Staff Report to the Plan Commission

Estates at Ravinia Meadows by Pulte

Project: 2024-0676 – Estates at Ravinia Meadows – Special Use Permit **Amendment** for a Residential Planned Development

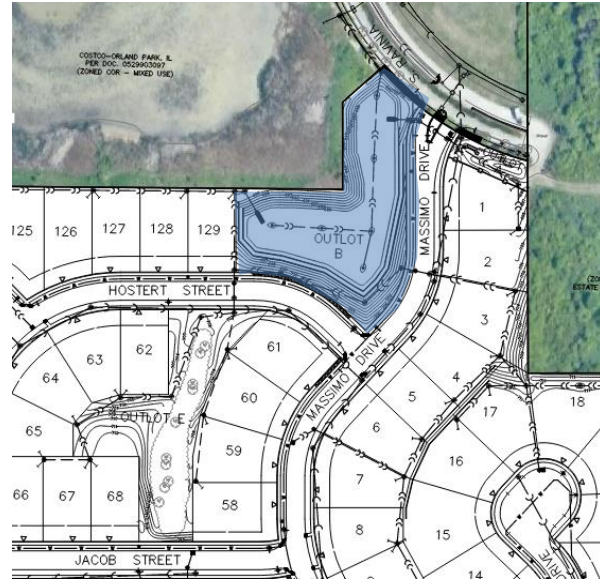
- Expansion of Outlot B to accommodate volume control for stormwater management via a bioswale for the northern portion of the Pulte project.
- Reduction in the number of housing units from 132 to 129, to accommodate expansion of Outlot B.

3 units shown in yellow have been eliminated, reducing the total number of units from 132 to 129. This allows an expansion of Outlot B which contains a bio swale providing storm water volume control for the northern portion of the site.

Estates at Ravinia Meadows – Site Plan

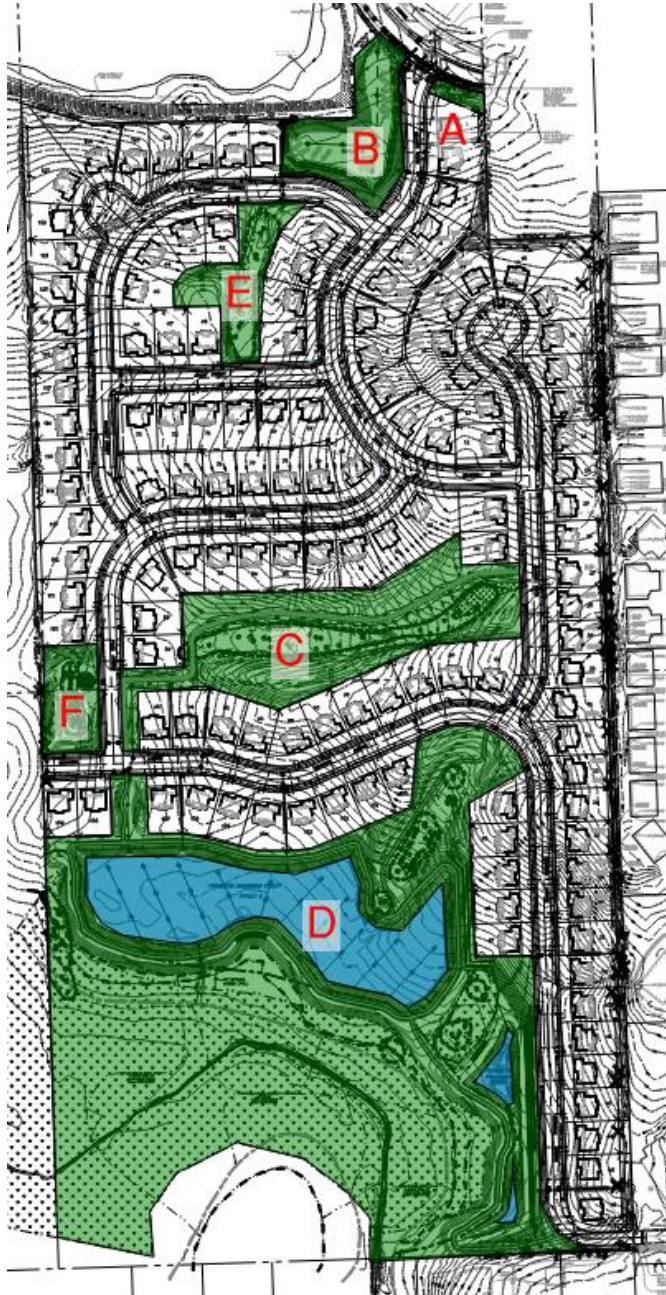
SITE PLAN The site plan indicated 129 dwelling units, and six outlots (A,B,C,D,E & F).

Outlot B is also located along Ravinia Avenue and will provide stormwater volume control for the northern portion of the site.
